DATE: May 20, 2015

SUBJECT: Revisions to the Minimum Use Driveway Highway Occupancy Permit Application for Unconventional Oil and Gas Development Drilling and Fracking Operations

MINIMUM USE DRIVEWAY DESIGN FOR UNCONVENTIONAL GAS DRILLING AND HYDROFRACKING WELL SITES

MINIMUM USE DRIVEWAY PLAN

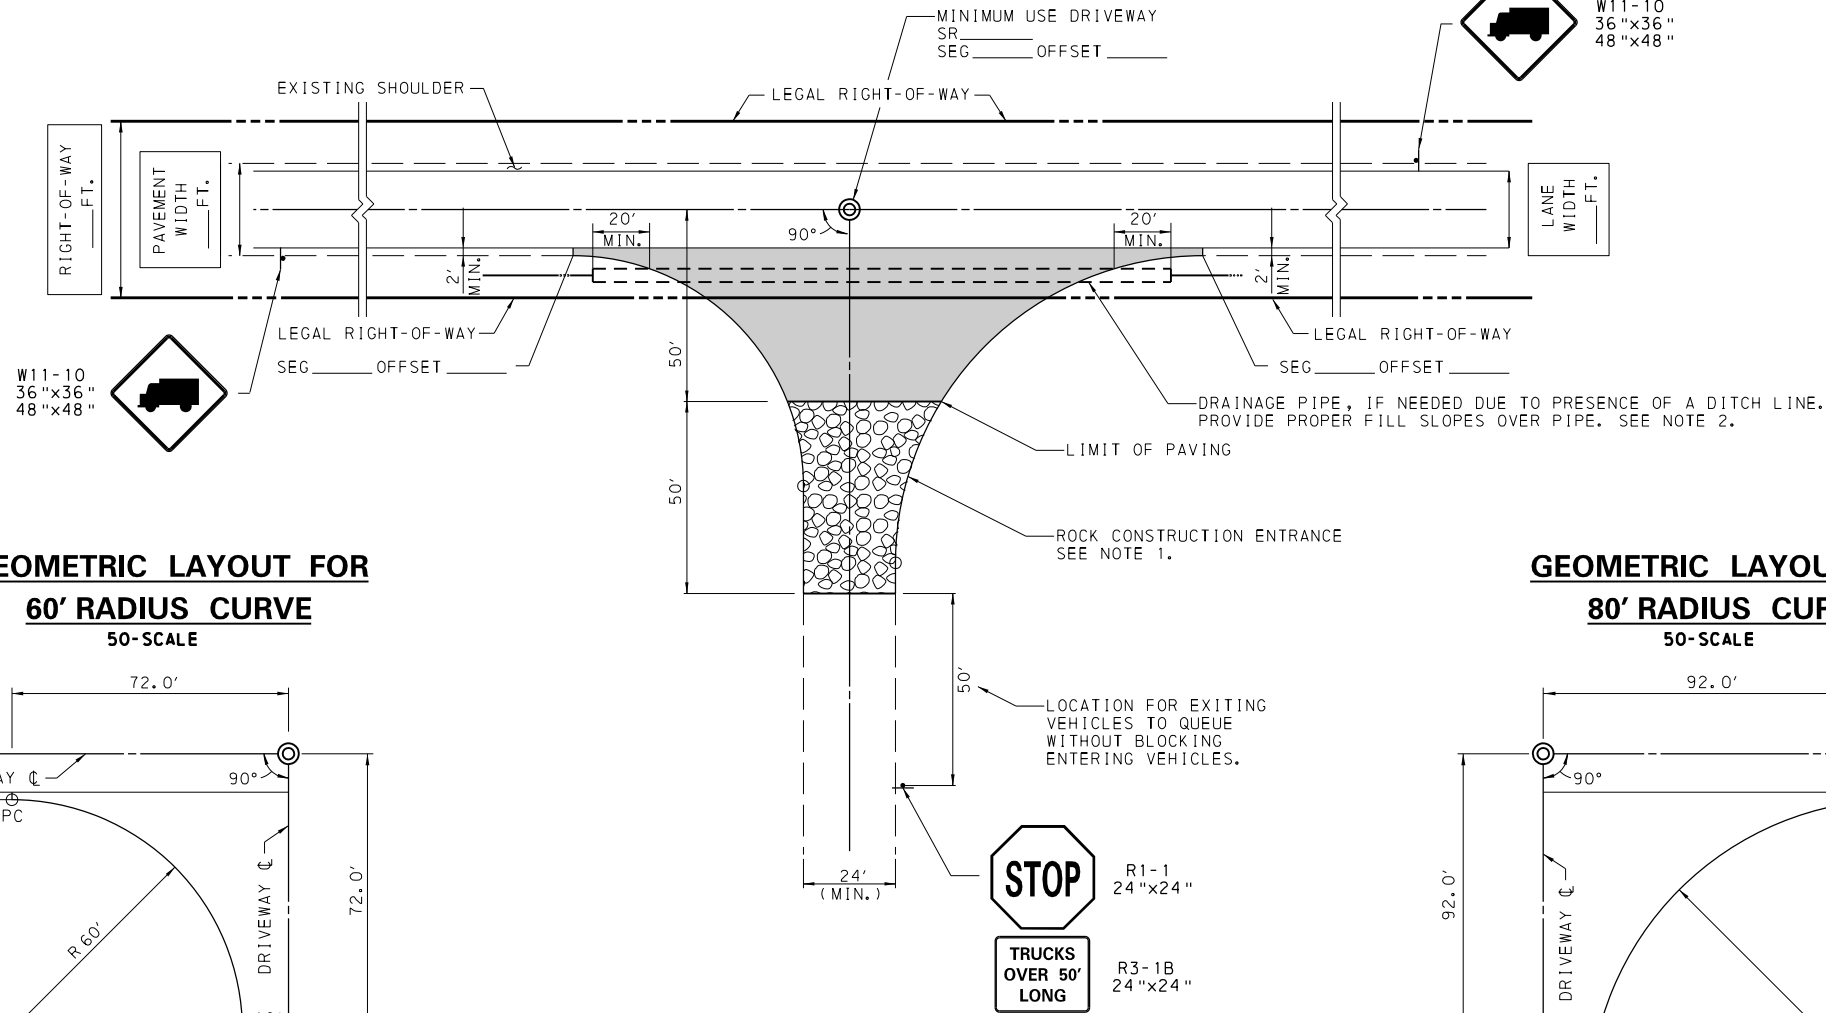
- A drainage pipe is now depicted under the driveway.
 - Added dimension labels indicating the 20' minimum extension of the drainage pipe on either side of the driveway.
 - Included the associated note "DRAINAGE PIPE, IF NEEDED DUE TO PRESENCE OF A DITCH LINE. PROVIDE PROPER FILL SLOPES OVER PIPE, SEE NOTE 2."
- Replaced the W25-5 Construction Entrance Ahead Sign with the W11-10 Truck Crossing Sign
